Request for Bids for the Franklin County Sanitary Landfill 2025 Gas Collection and Control System Construction Project

This Addendum No. 3 shall be considered part of the RFB for the Franklin County Sanitary Landfill 2025 Gas Collection and Control System Construction Project and is intended to correct, change, and/or add to the documents as described below. Please make sure to complete the Addenda Acknowledgement form included in the *Required Documents*.

# CONSTRUCTION PLANS FOR THE 2025 GAS COLLECTION AND CONTROL SYSTEM FRANKLIN COUNTY SANITARY LANDFILL GROVE CITY, OHIO

APRIL 2025  
**ADDENDUM 3**

**2025 GCS CONSTRUCTION  
PROPOSED CONSTRUCTION SITE PLAN**

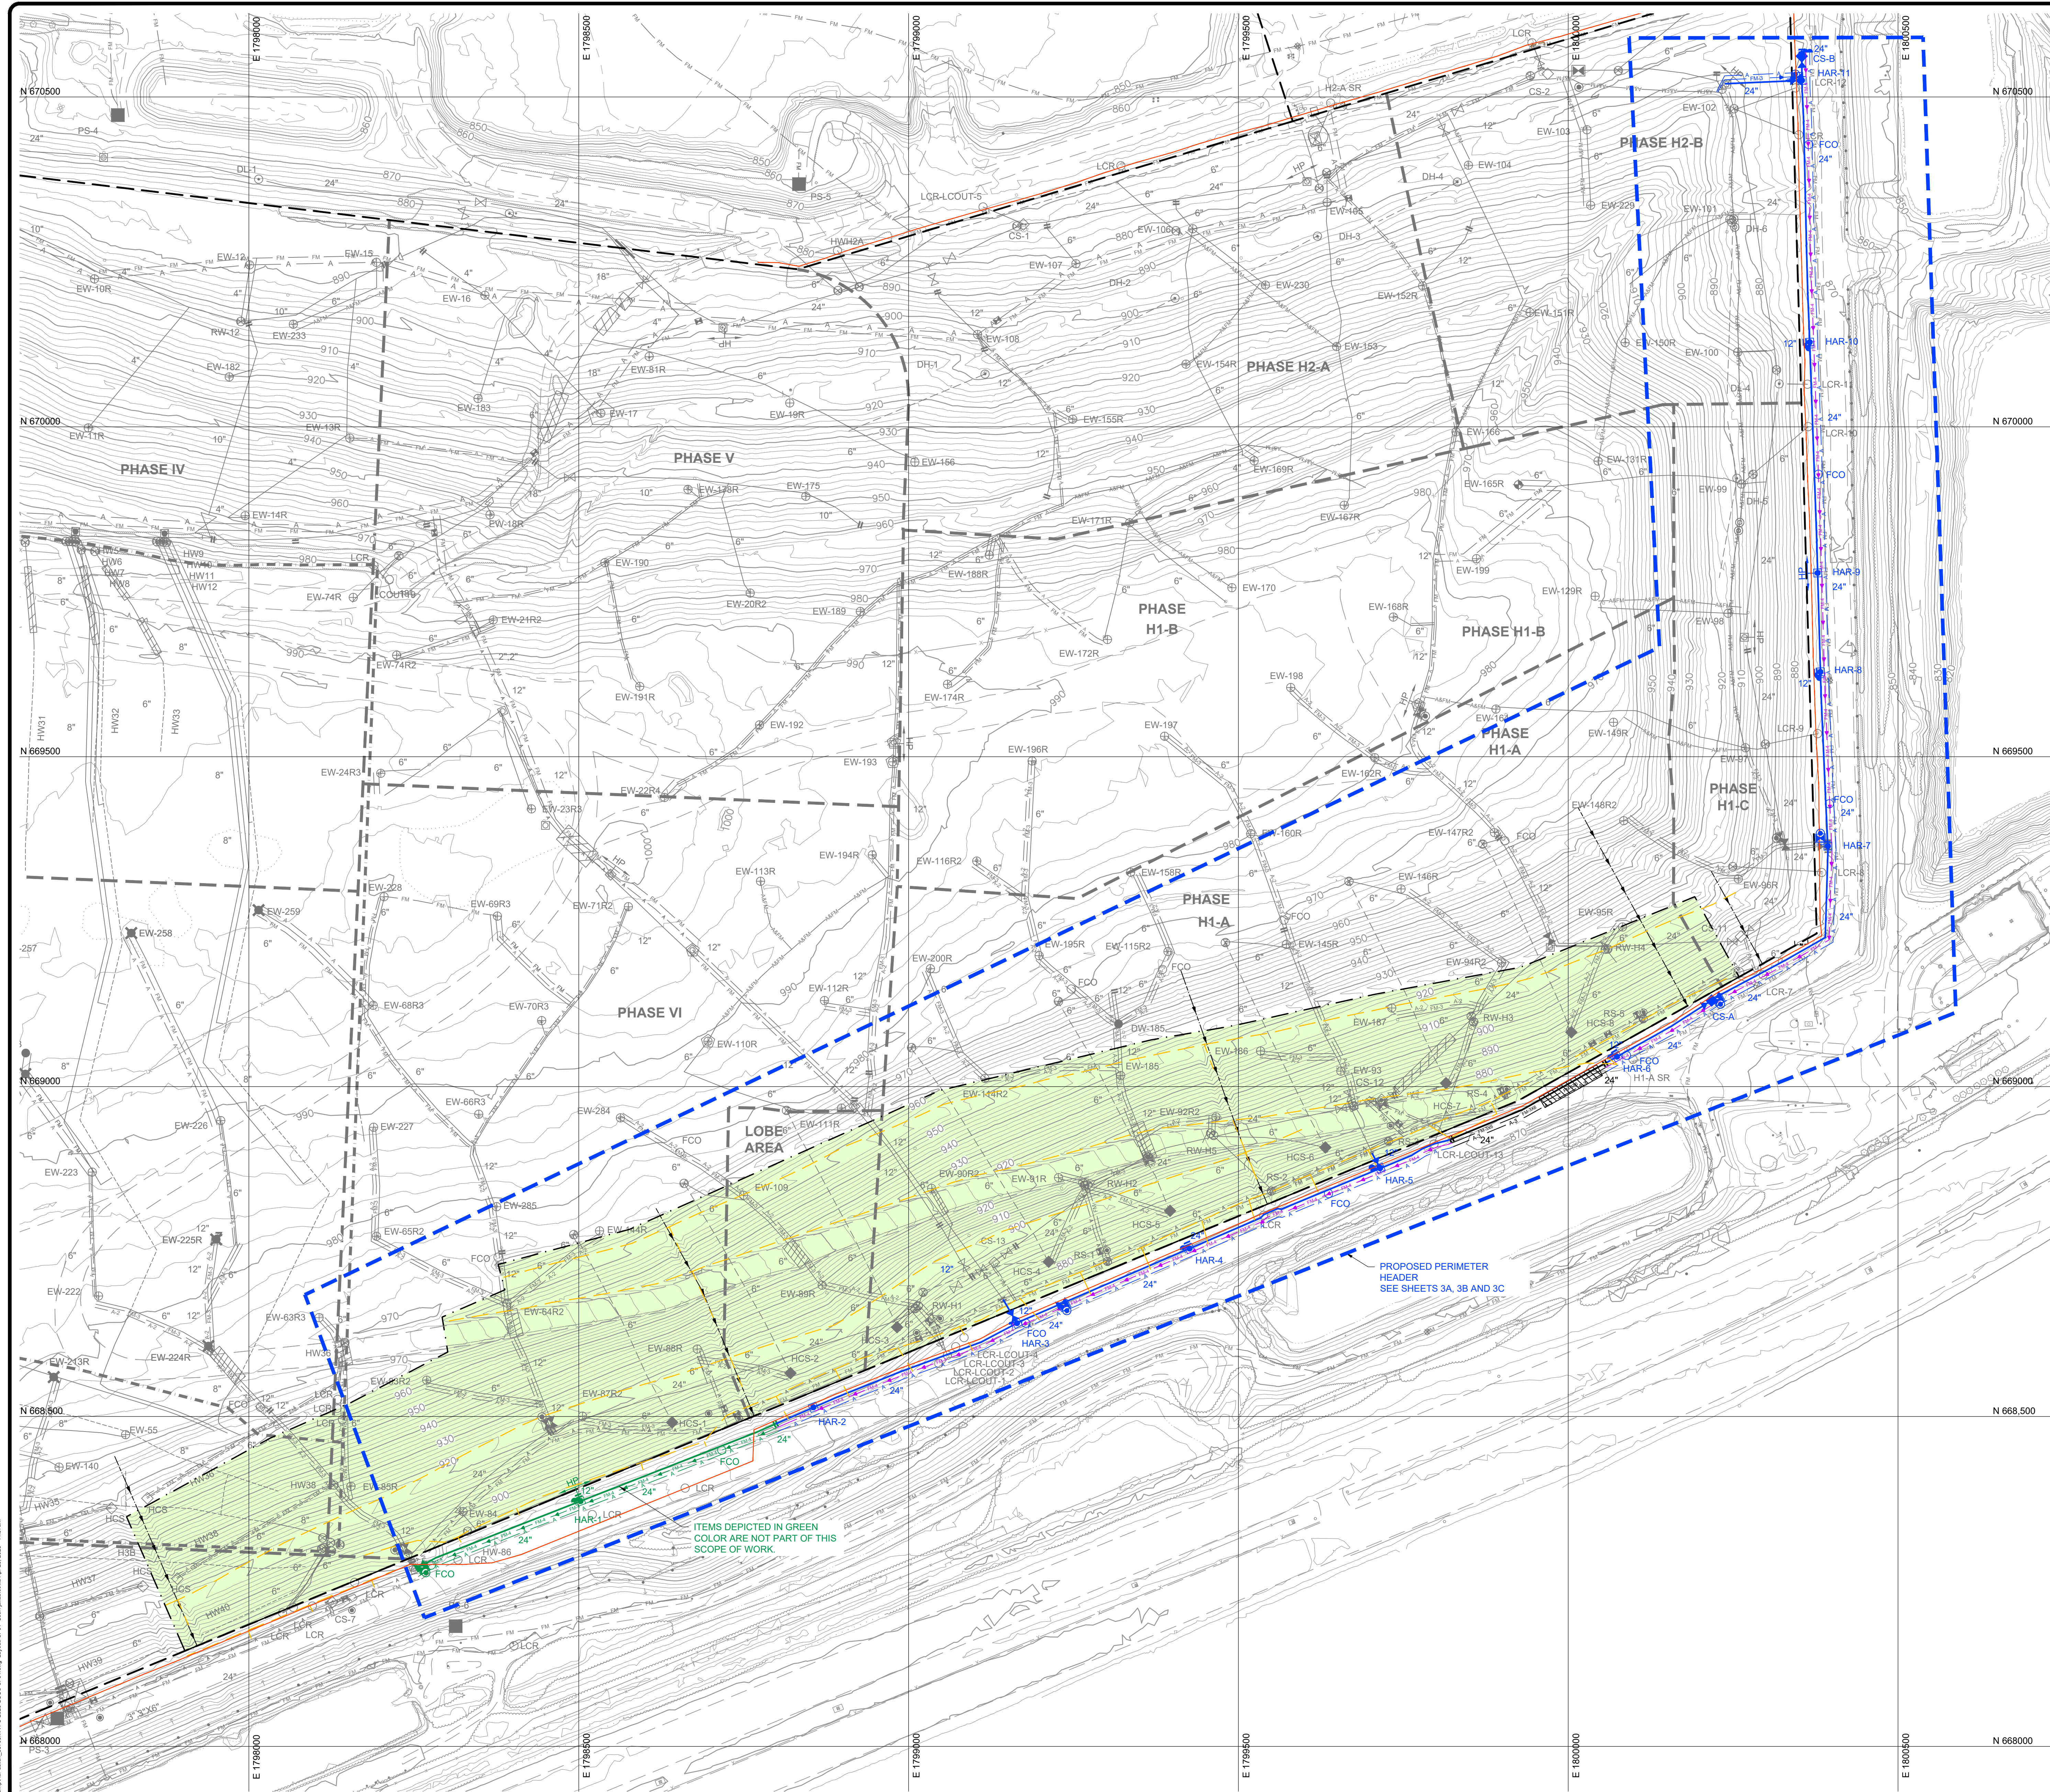
Question #33: *The drawings show 3 anti-seep collar locations and the bid form is showing only 2, please advise.*

Answer: Only one (1) anti-seep collar needed for the Project. Bid Tab item 121 and drawings are revised and attached.

SHEET NO. **3C**  
PROJECT NO. 206-4251380

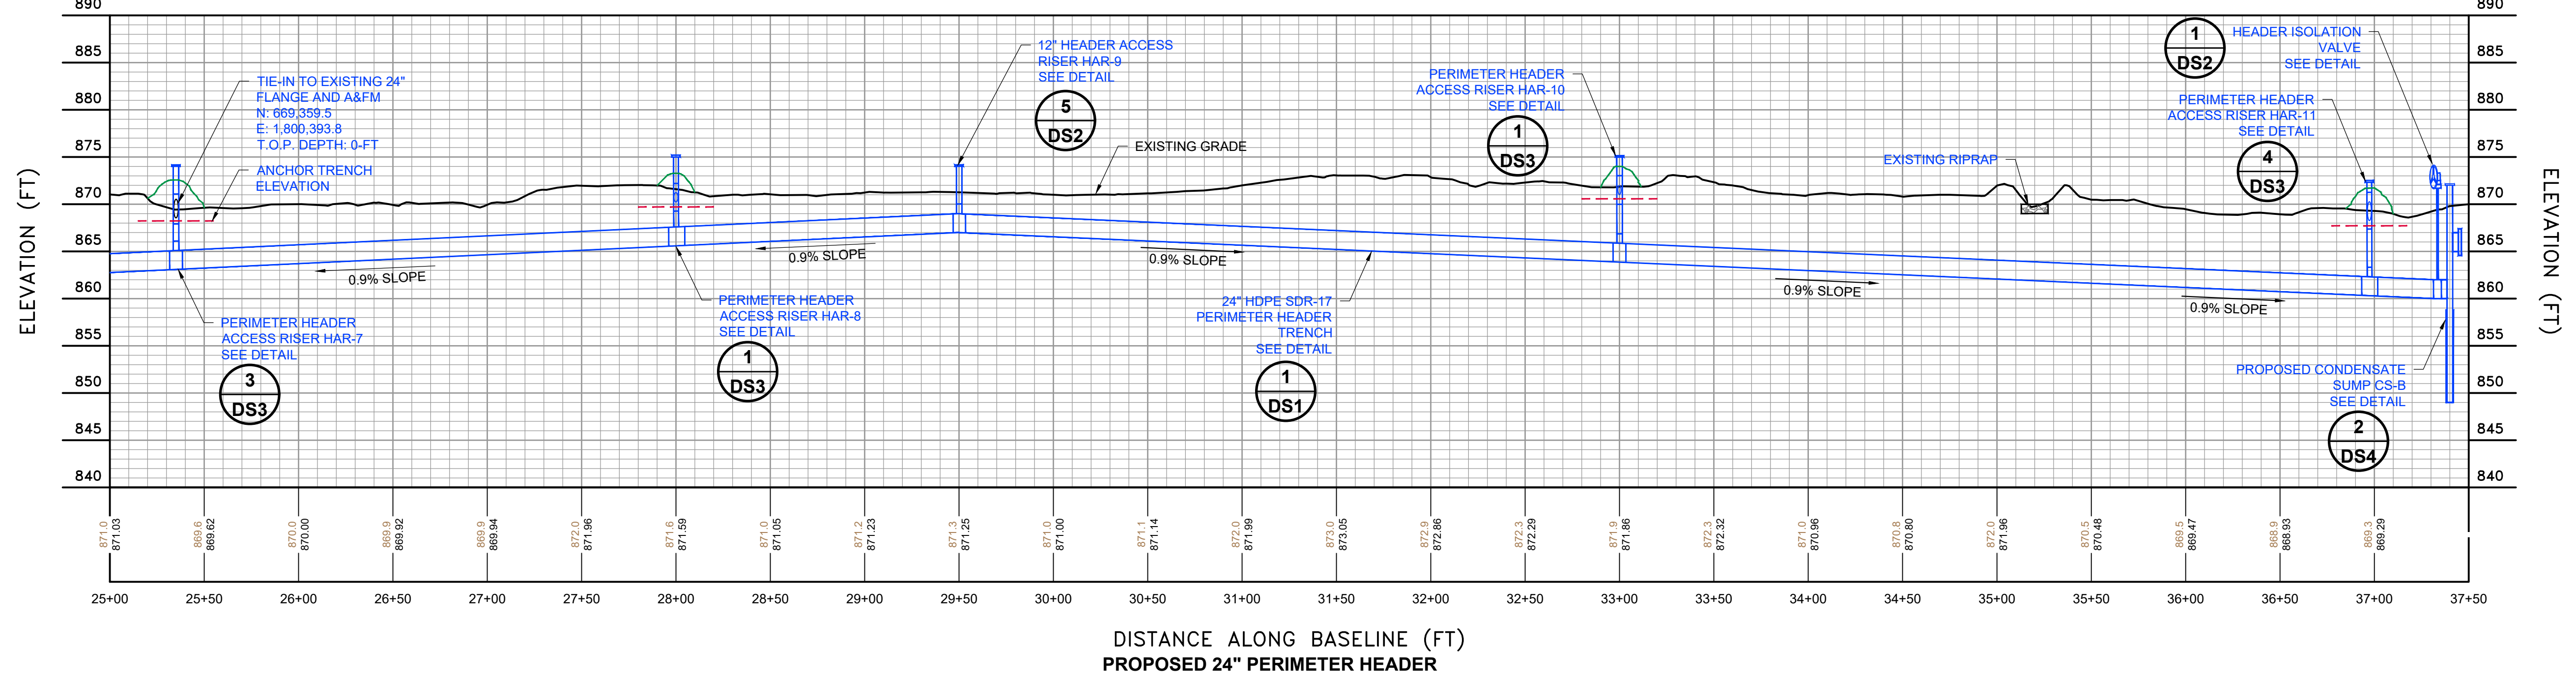
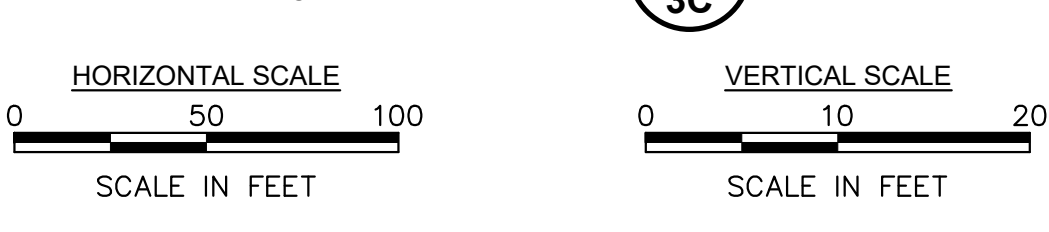
Question #37: *As for the road crossing detail, it looks that there is a ditch crossing instead of a road crossing? What would be the top width of the said road? Also, what materials are called out as base and subbase?*

Answer: There is no road at station 35+00. There is an existing let down with riprap and culvert box with pipes. The culvert box with pipes is close to the road and will not be in the way of the header trench. However the trench excavation will go through the existing riprap, which will need to be reestablished after header installation. Plans and bid tab are updated to reflect the changes.
